Detailed Site Plan Departure from Parking and Loading Spaces McDonald's Stuart Lane

DSP-19058
DPLS-476

SUBJECT: Detailed Site Plan DSP-19058
Departure from Parking and Loading Spaces DPLS-476
McDonald's Stuart Lane

2
A2.1 NON-DRIVETHRU ELEVATION
SCALE = 1/4"=1'-0"

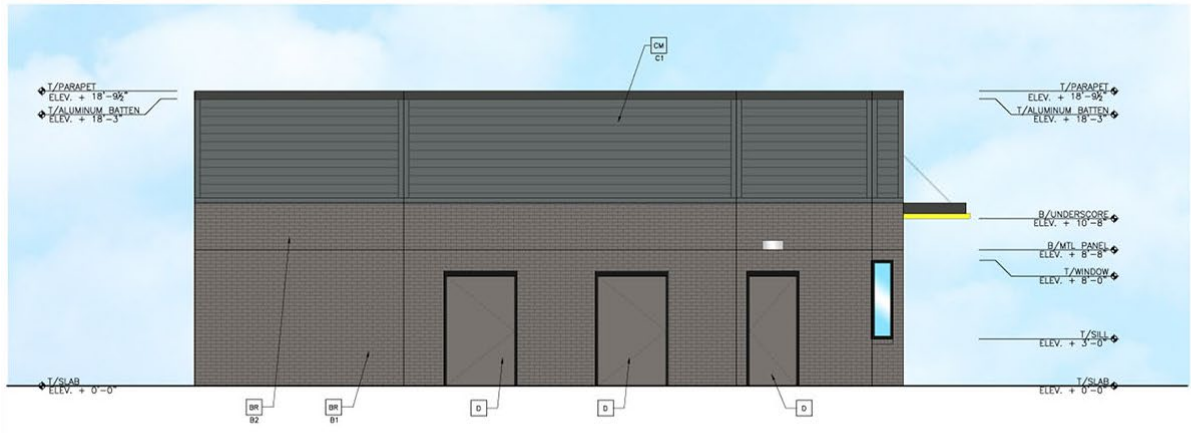
- c. Provide the cardinal points on the building elevations.
 - d. Revise the proposed building-mounted signs and areas to be consistent in the signage table, the architectural elevations, and the details provided on the DSP, and in conformance with Section 27-613 of the Prince George's County Zoning Ordinance.
